GREENBERRY, LOT 21
5007 ALTOGETHER WAY, CLARKSVILLE MD
TAX MAP 28, GRID 09, PARCEL 48
HOWARD COUNTY
FIFTH ELECTION DISTRICT
REVISED PERCOLATION CERTIFICATION PLAN

Project No. 15-005
Project Name: Greenberry – Lot 21
Address: 5007 Altogether Way

The perc cert plan was reviewed with the following comments:

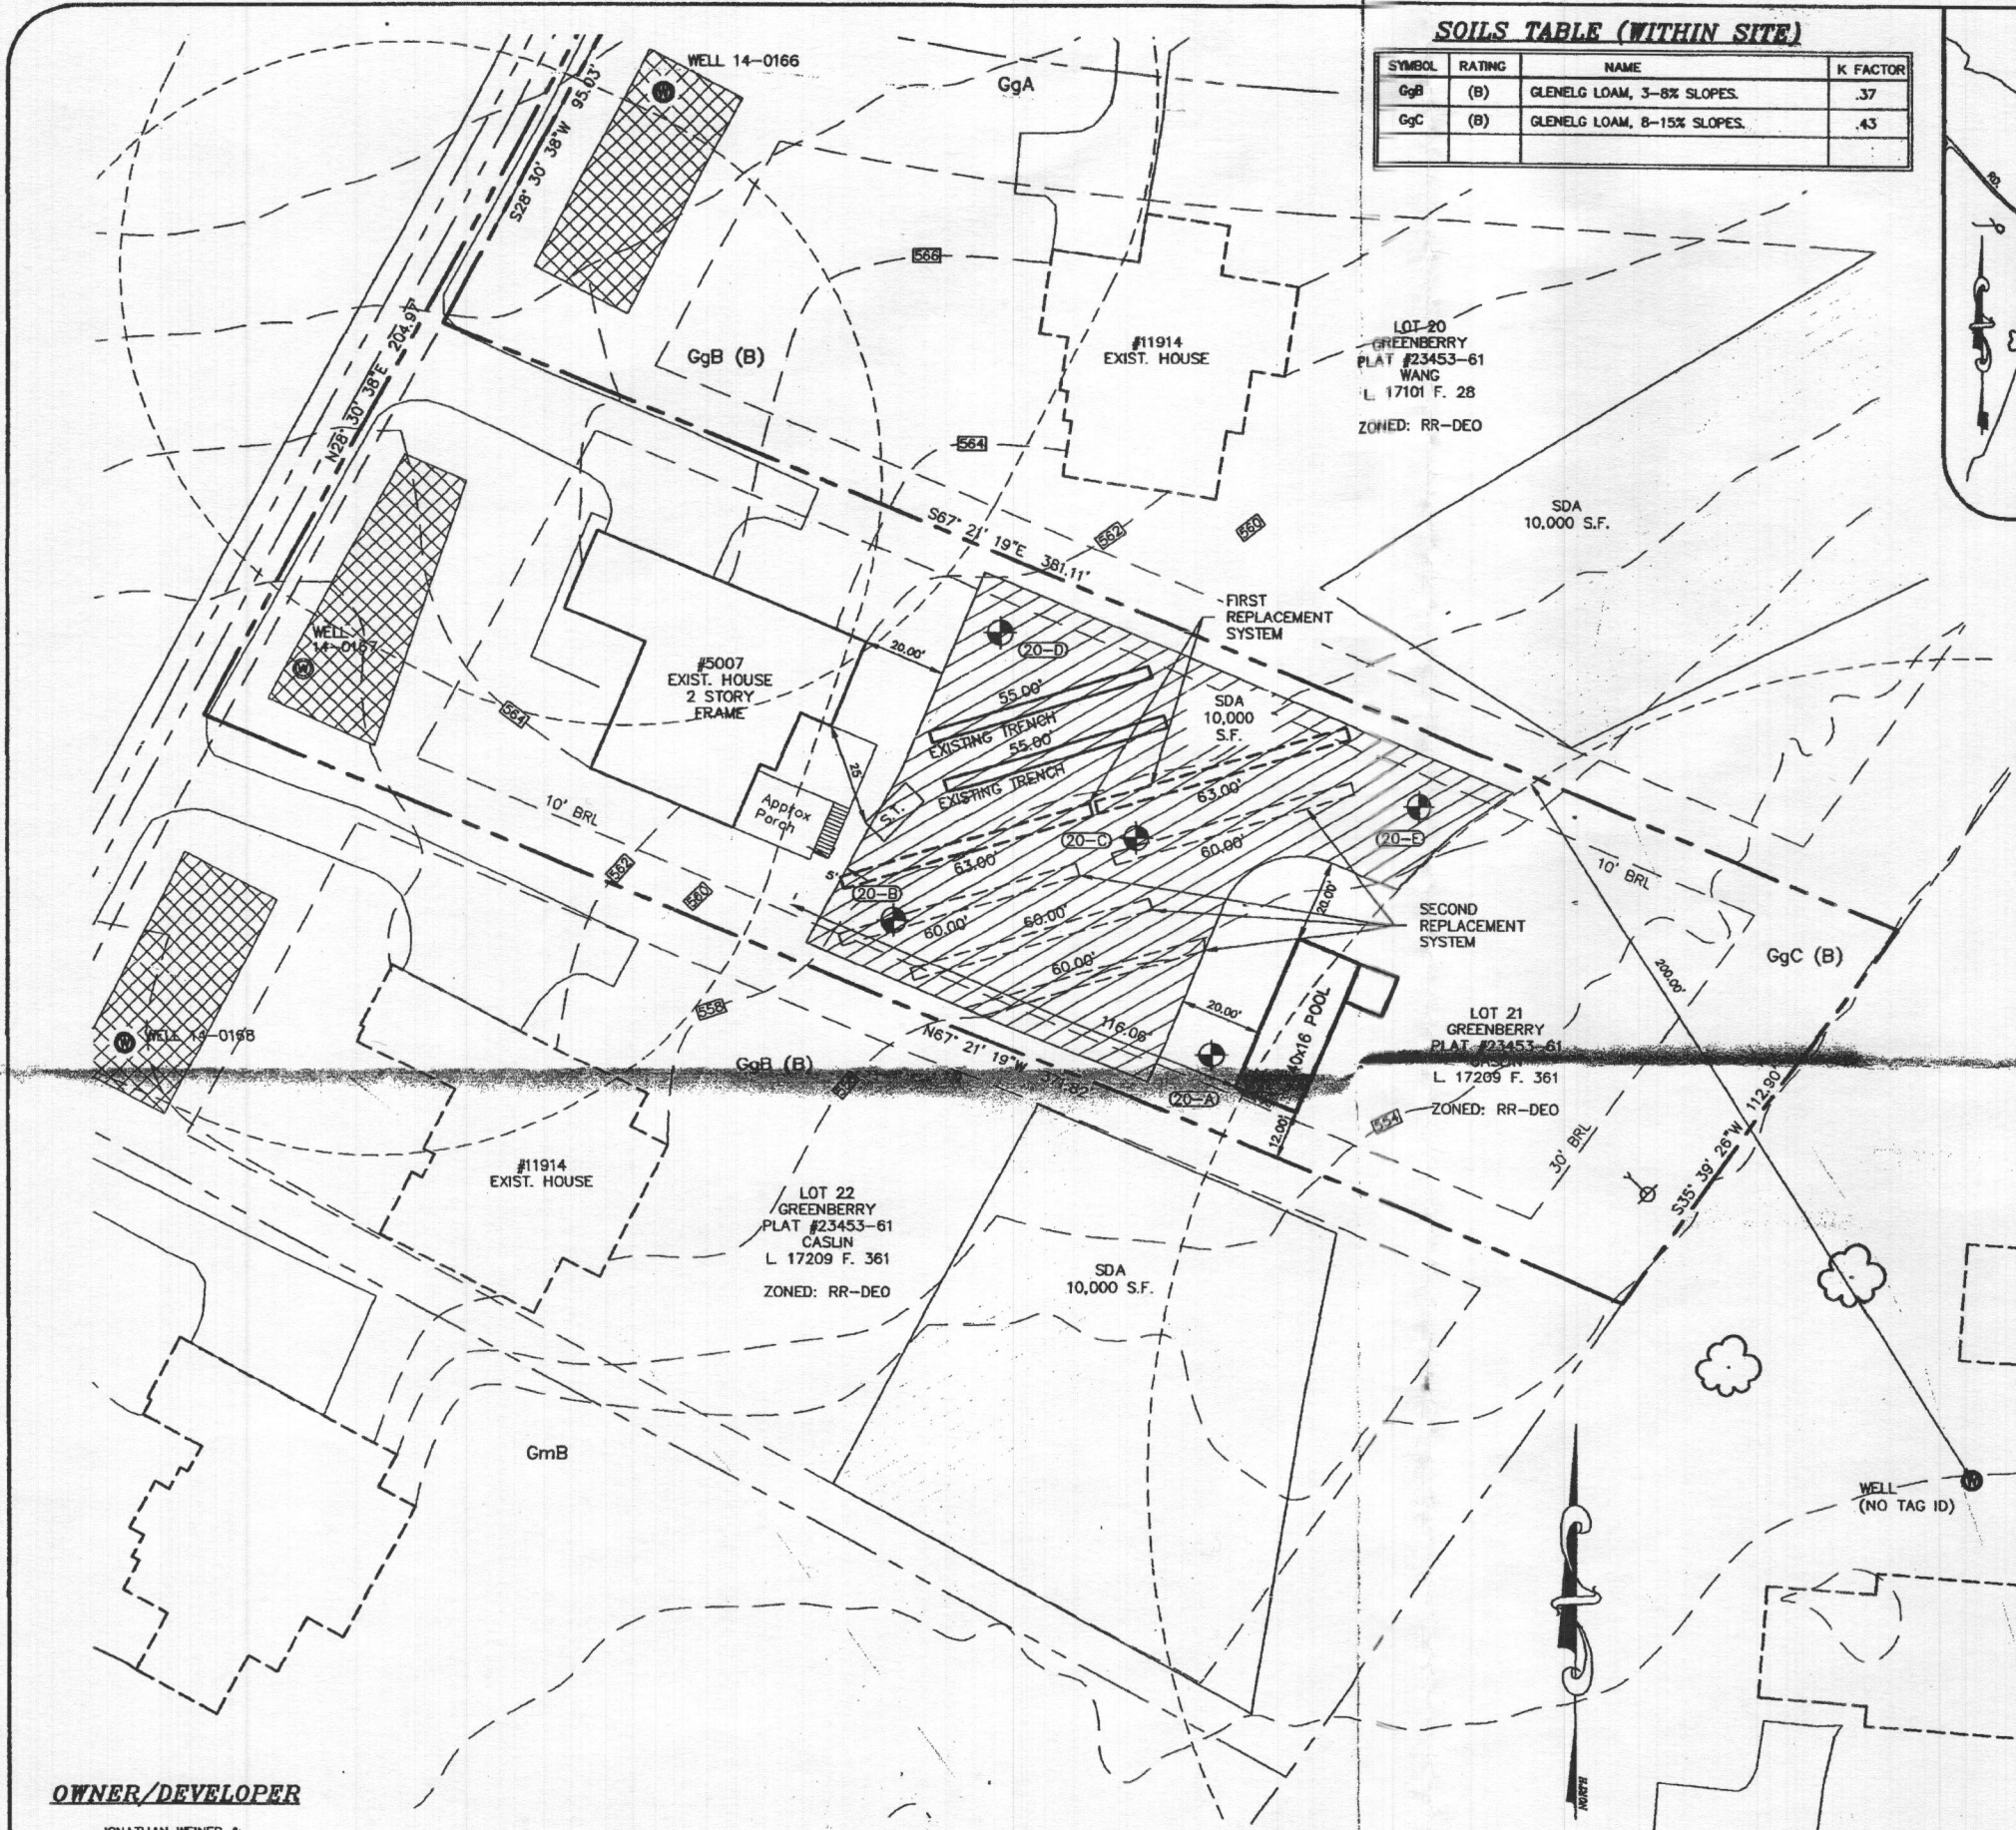
1.) *Label each test hole with their appropriate #.*

2.) *Add a purpose statement.*

3.) *Label replacement systems on plan*

4.) *According to the As-built, each existing trench is 55 feet long (not 54).*

5.) *Did you use my specs to calculate the amount of trench for the replacement systems? Provide supplemental calculation sheets with next submittal.*

6.) *This is lot 21 (not 22)*

The five (5) Percolation test holes have been labeled (i.e. 20-A, 20-B,20-C,20-D,20-E).

A purpose statement has been added above the general notes.

The first and second replacement systems have been labeled.

The existing trenches have been corrected to match the as-built of 55'.

Supplement calculation have been provided with this submission.

The Lot label has been corrected.

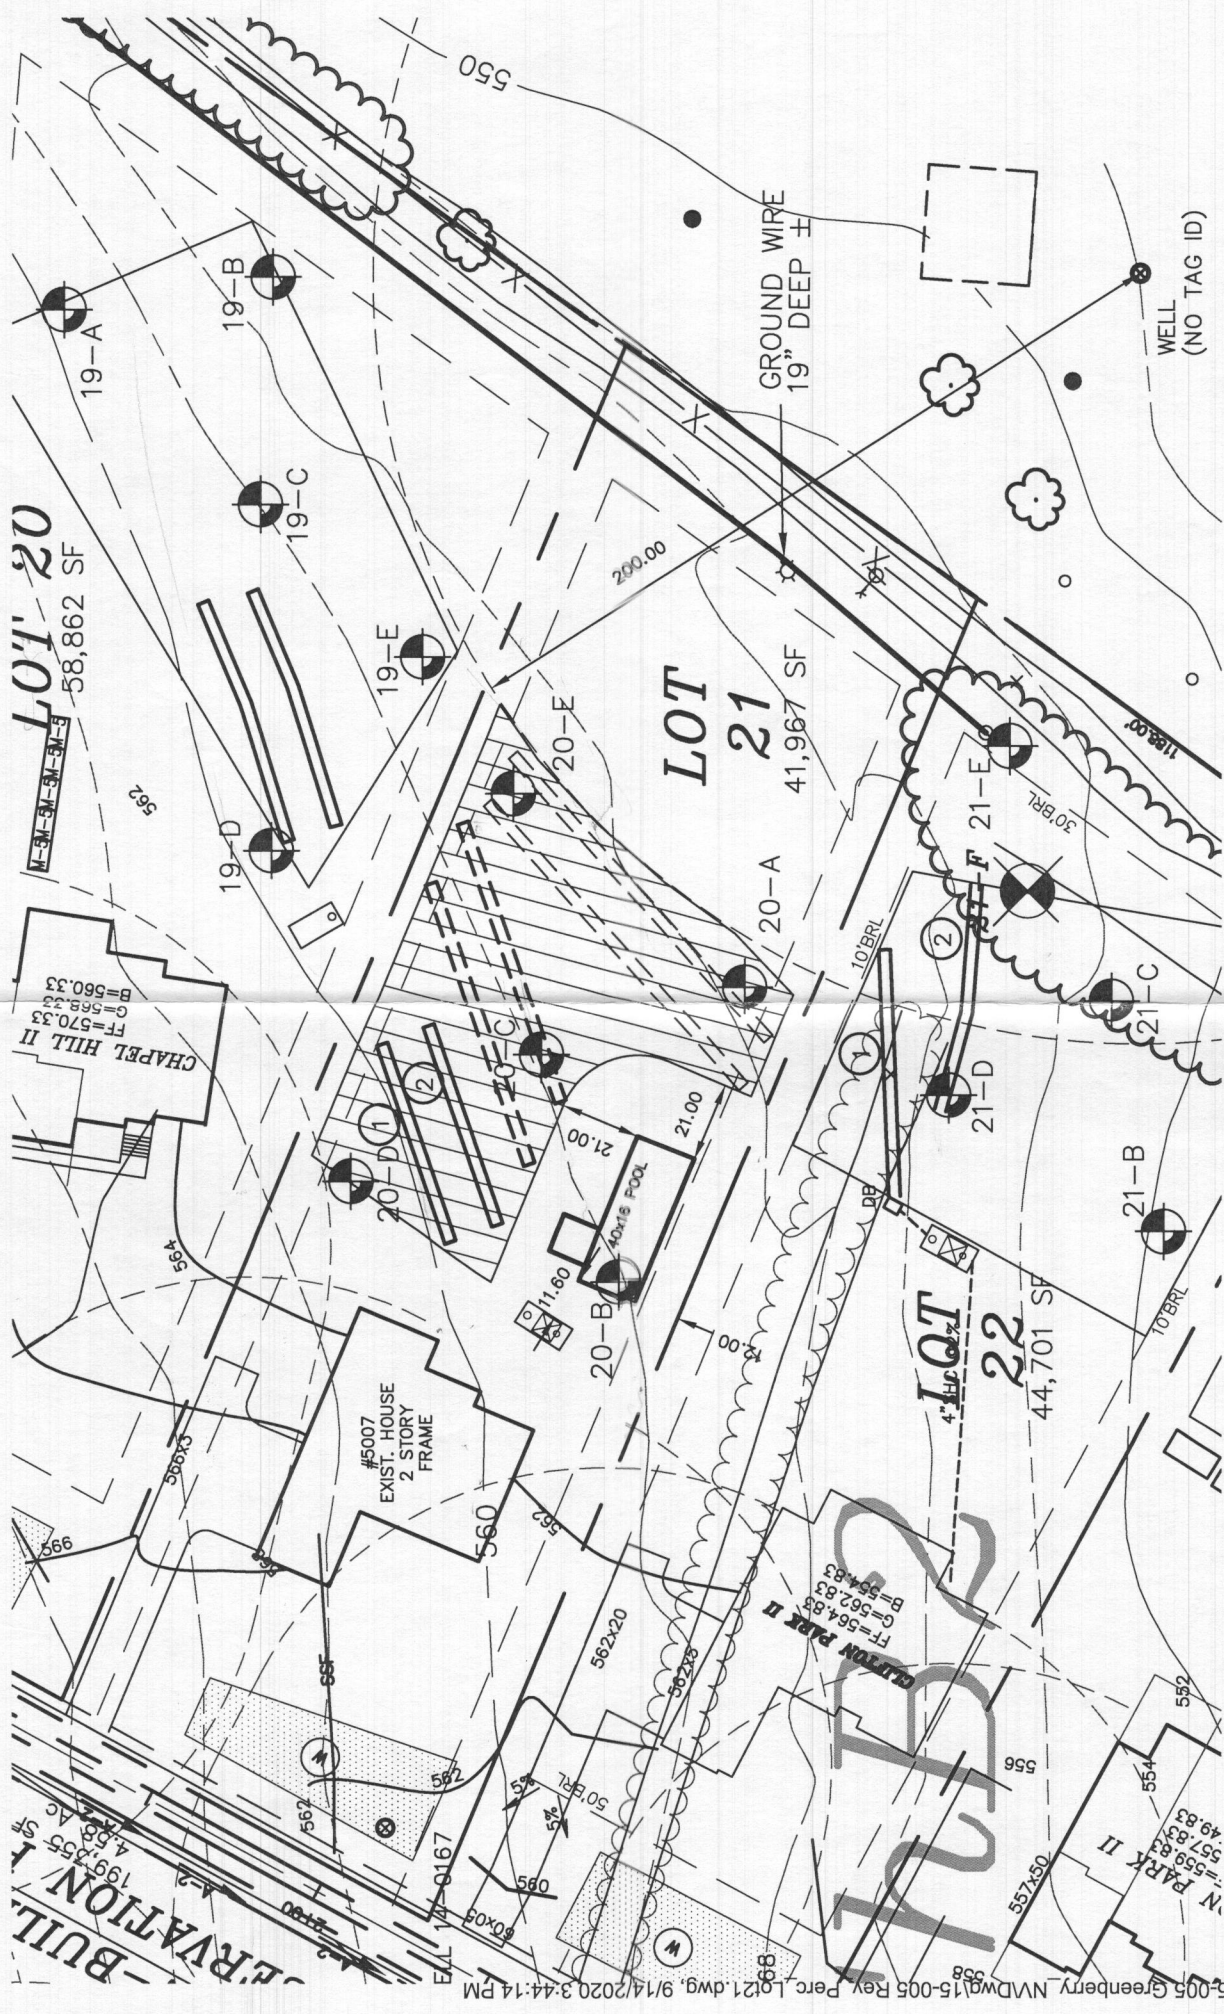
The expansion of the sewage disposal area (SDA) seems okay, but one replacement system is way off contour and the proposed pool looks to be under 20 feet from the new SDA. As mentioned, there is a downgrade well and a variance, so you can go down a bit, but the area must stay over 200' away from the well. Additionally, you can go down to the 556 contour line without additional testing and can go to 5' of the property line. Also, you will need to retain 10,000 sq. ft. area and show how 2 replacement systems fit on contour with the new SDA. The existing trenches must be field located and shown accurately on the new perc cert plan. Lastly, you will also need to get an engineer to work on the adjustment.

- 1:50
- * tank field located
- * what's the sq. ft. of new SDA,
- * what specs were used?

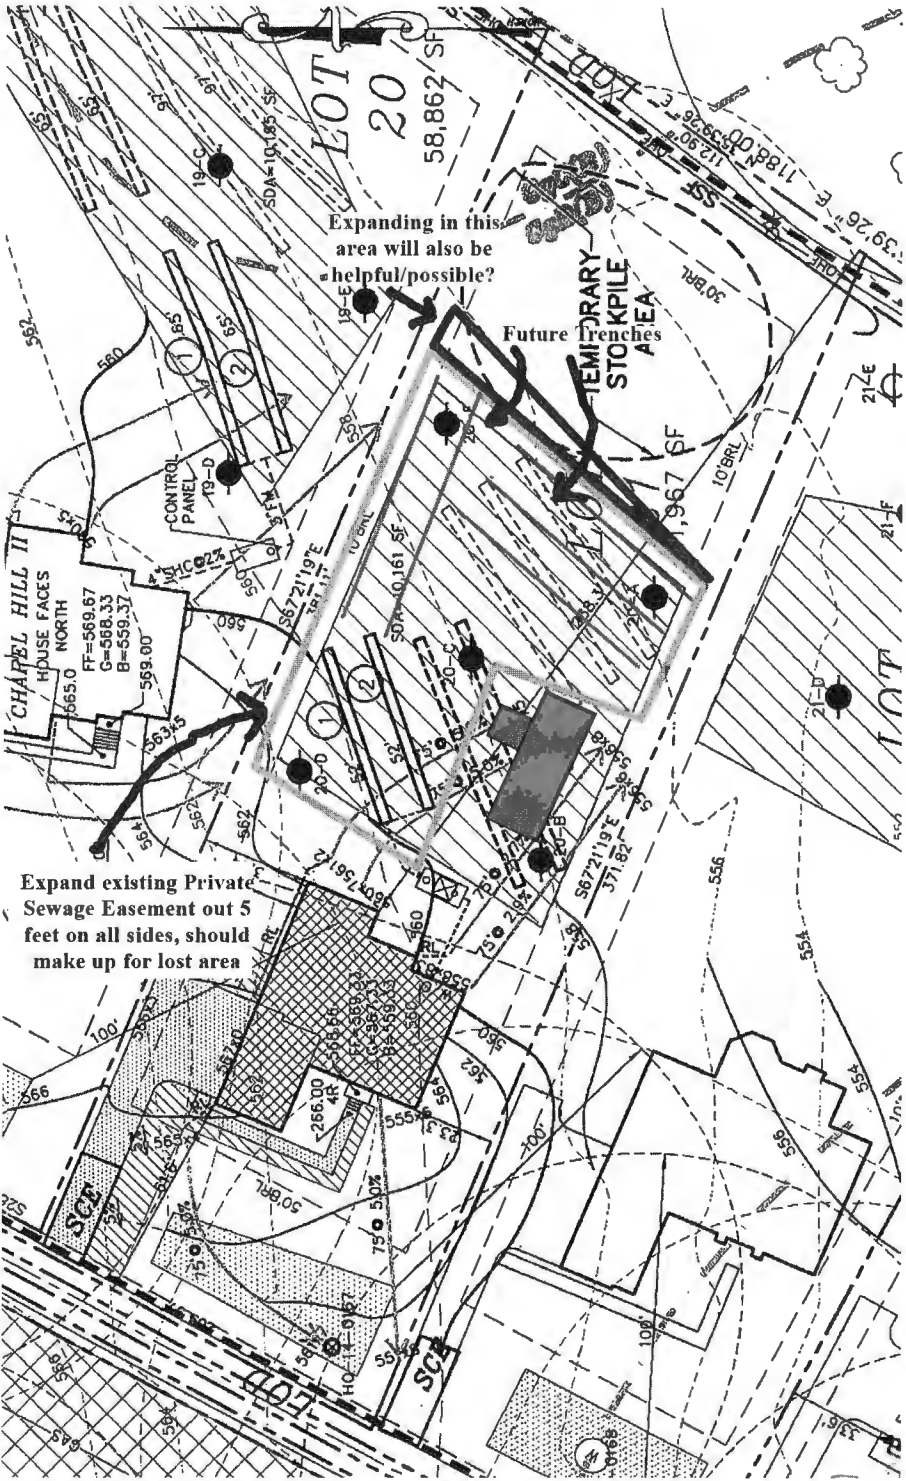
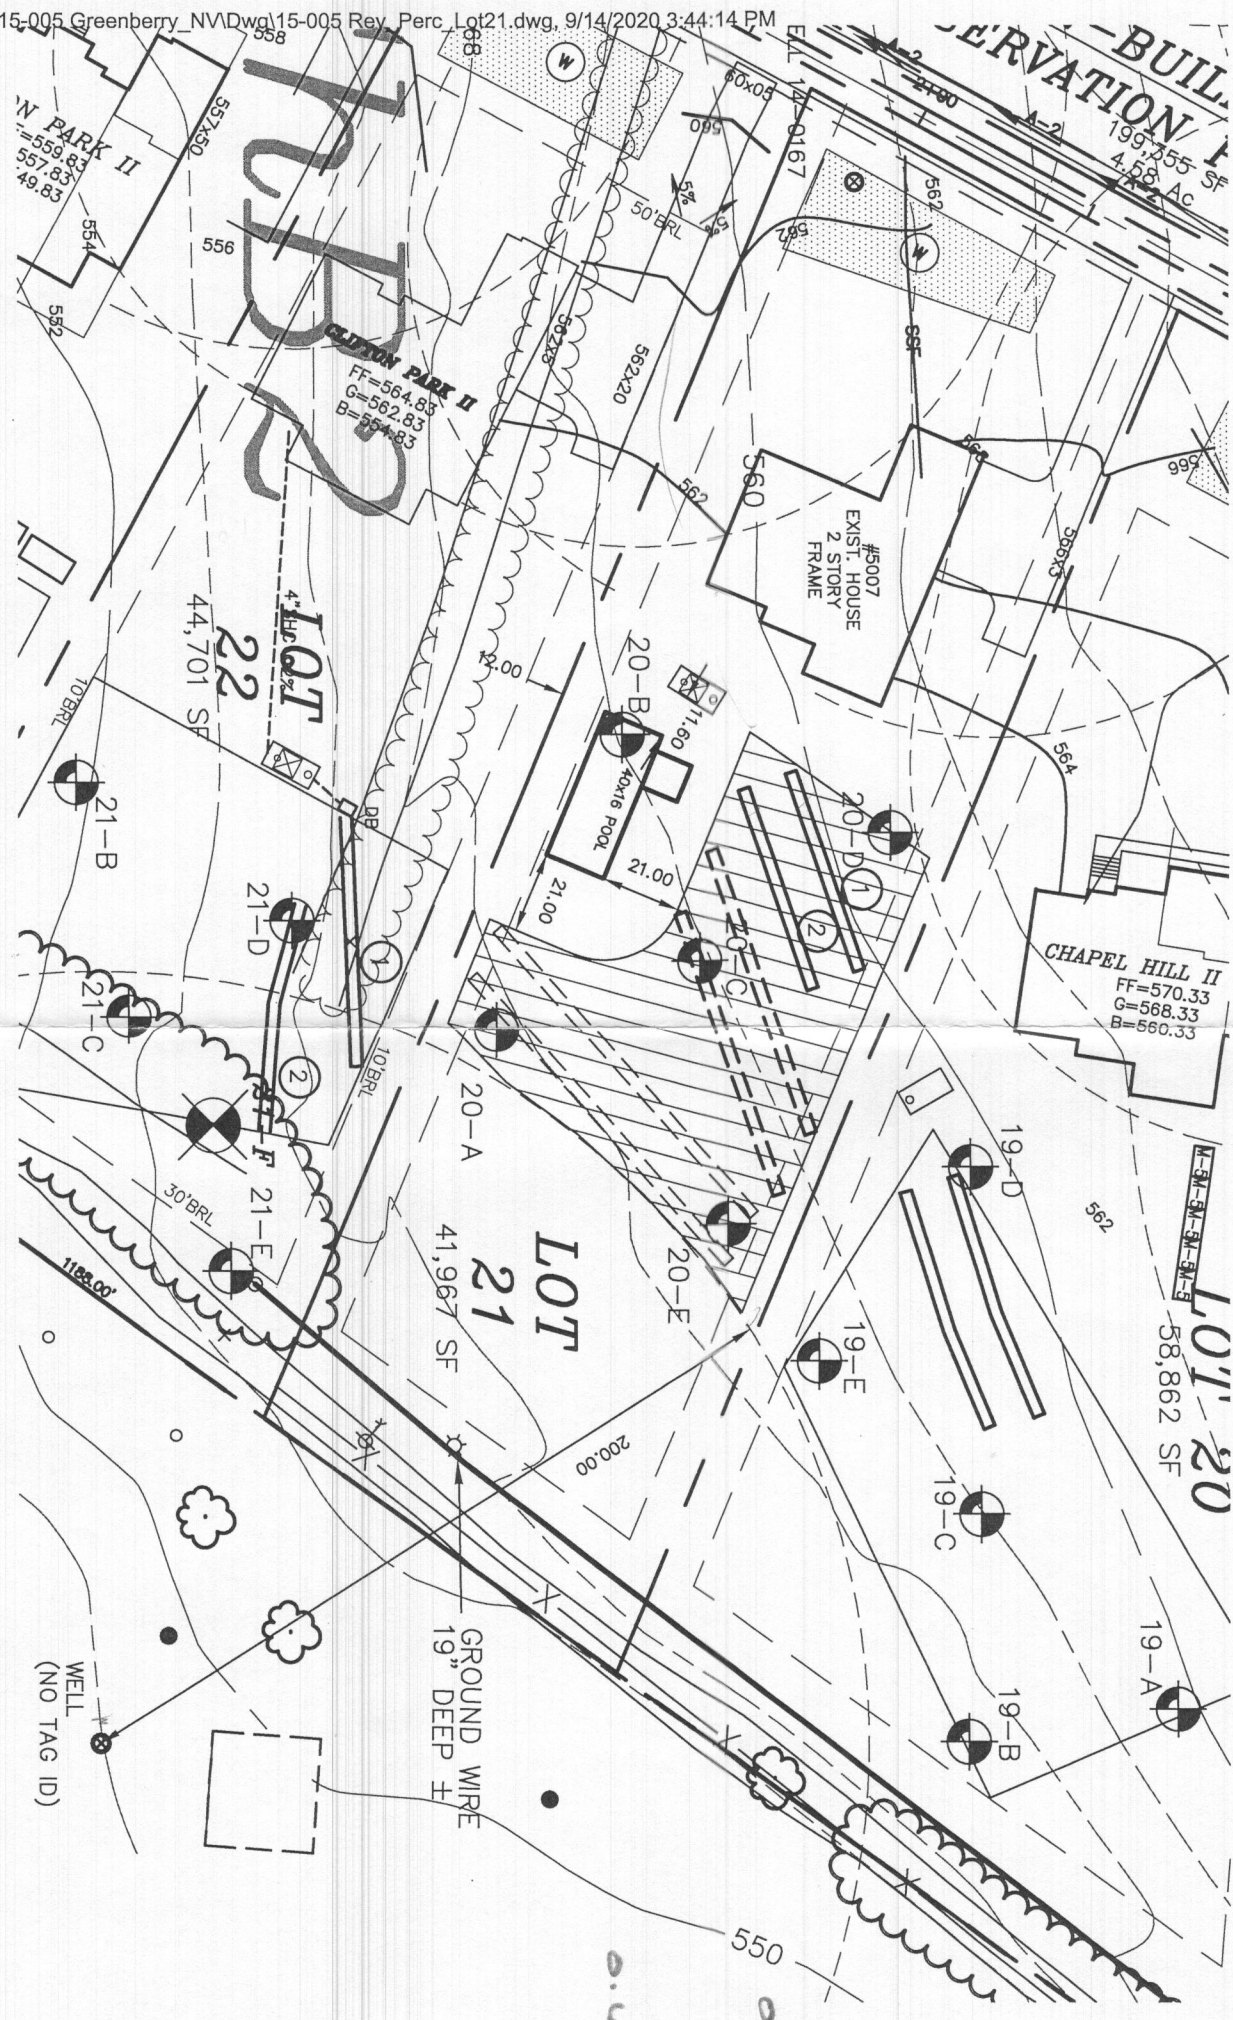
Attached is a pdf of a very rough plan for placing the proposed pool on my lot and changing the boundaries of the Private Sewage Easement and moving the locations of the future trenches.

Expanding in this area will also be helpful/possible?

Expand existing Private Sewage Easement out 5 feet on all sides, should make up for lost area
